CERTIFICATE OF APPROPRIATENESS

Property: 901 Heights Boulevard, Lot 12, Block 231, Houston Heights Subdivision. The property includes a historic 1,260 square foot, one-story wood frame single-family residence situated on a 7,500 square foot (50' x 150') corner lot.

Proposal: New Construction – *Resubmittal*

Construct a two-story garage apartment behind the contributing residence at the rear of the corner lot facing W 9th Street.

SOUTH ELEVATION – FRONT FACING W 9th STREET

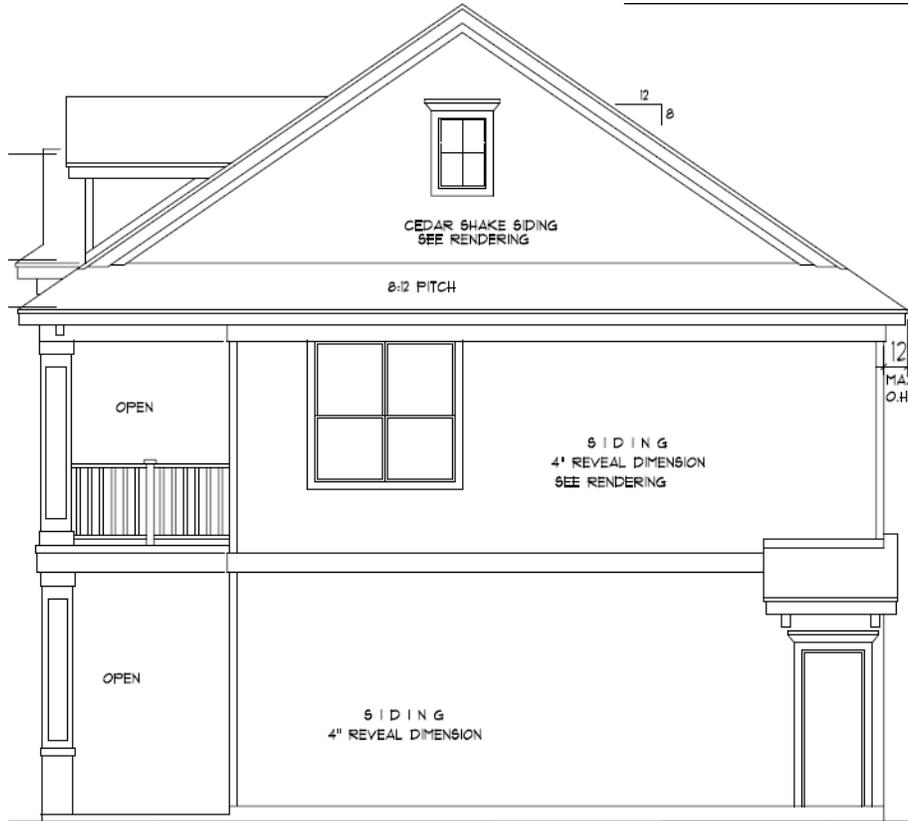
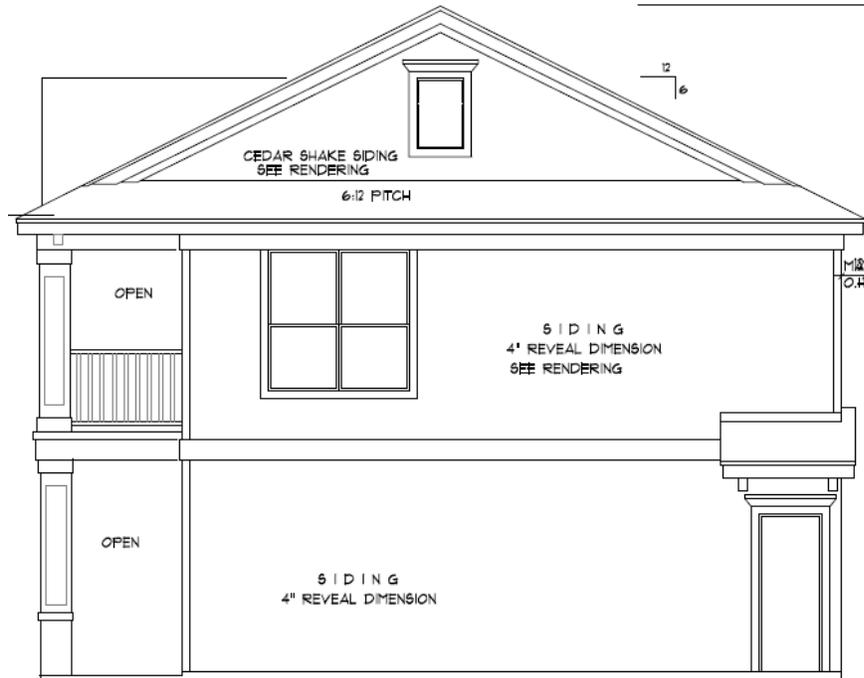
Garage apartments are common secondary structures found in Houston Heights. They are historically simple structures with little architectural detailing that are subordinate in scale and design to the main structure. The proposed new garage features excessive architectural detailing that is incompatible with the contributing structure at 901 Heights Blvd. Any detailing on the garage should take cues from the house and should be simplified.

Existing contributing garage apartments do not feature full width double gallery porches. The proposed gable-on-hip roof form, oversized paneled columns on brick bases, corbeled eaves and shake shingles on the gables are inappropriate, as they represent a higher level of detail than present on similar structures or the primary residence.

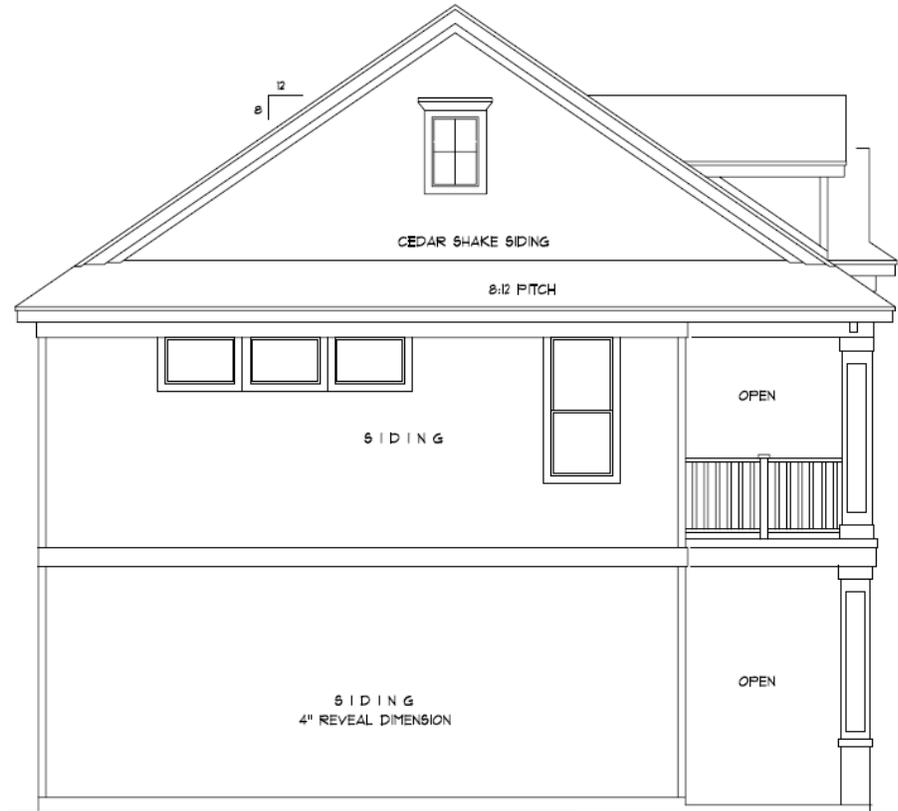
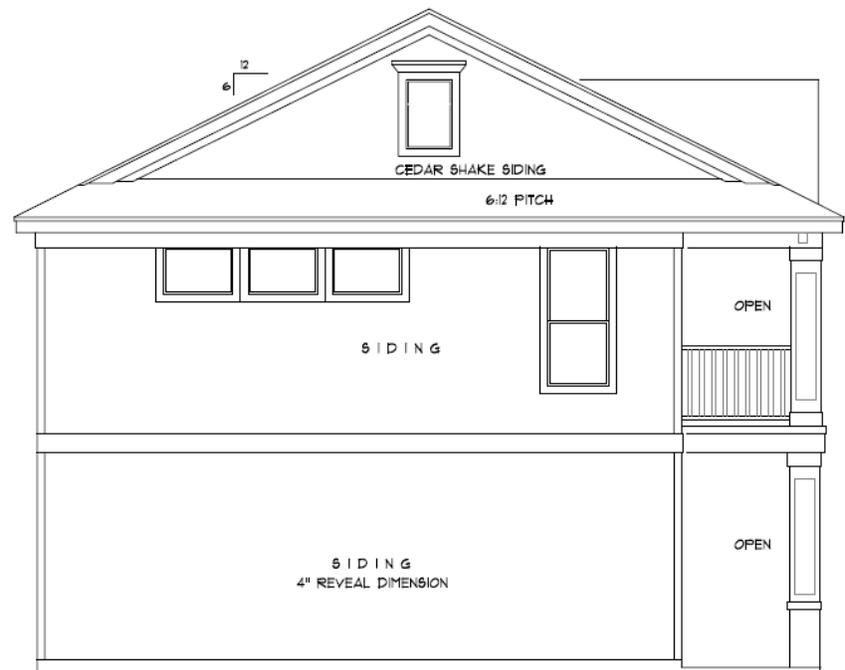
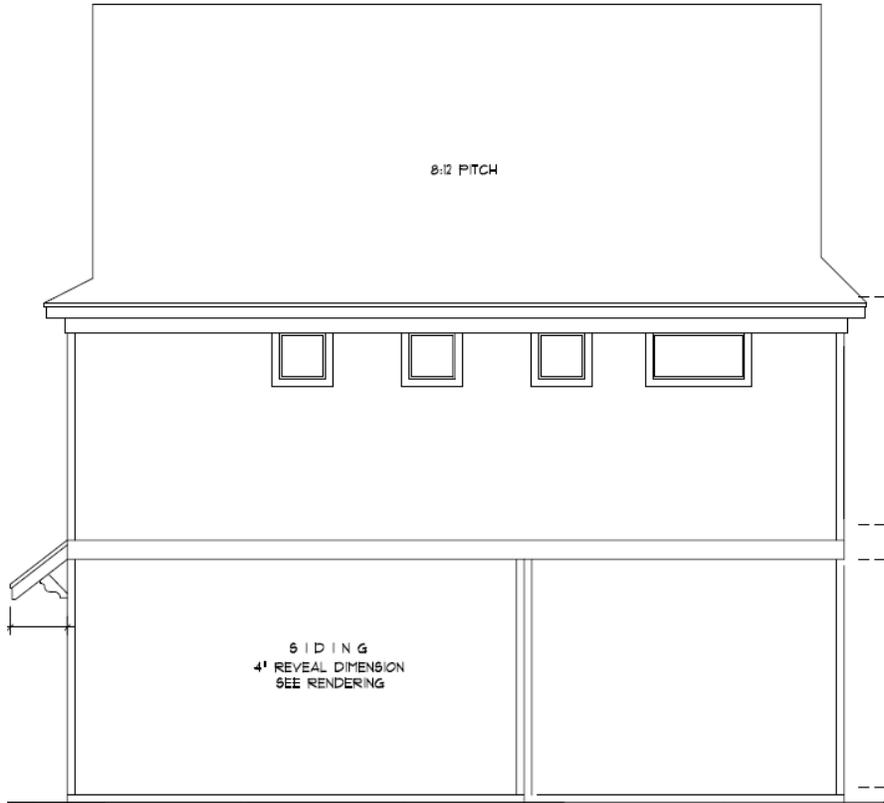
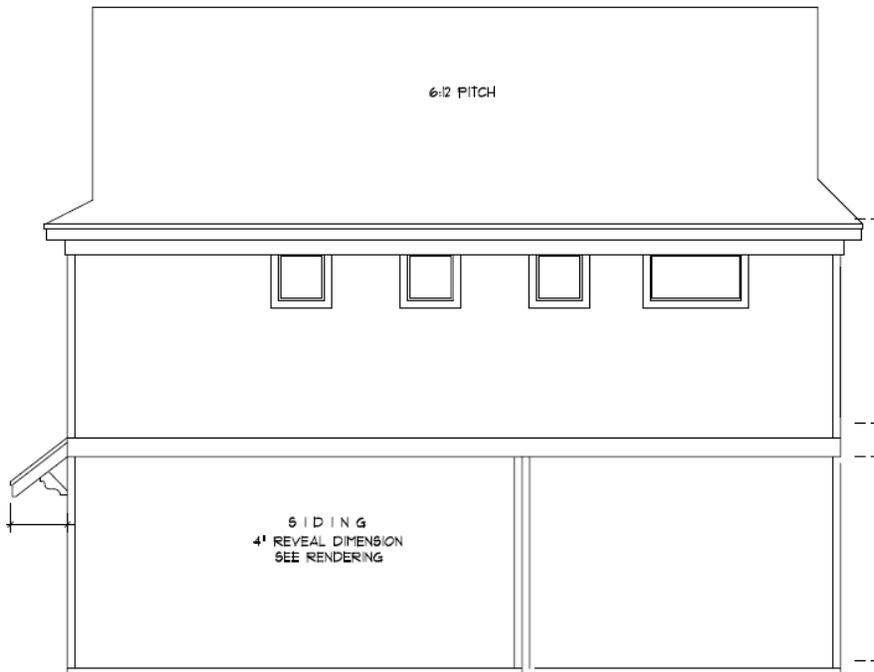
For the Second Time, I still **OBJECT** to the amount of fenestration proposed in this two-story garage structure. Historical character within the HSHD supports simplicity in visual design. This should be even more evident in garage accessory structures. The high level of fenestration including the proposed double gallery porch, multiple lite windows, oversized columns and shake shingles on an accessory, visual subservient structure is not appropriate. The proposed garage structure will place the existing residential main structure in visual subservience to the accessory structure.
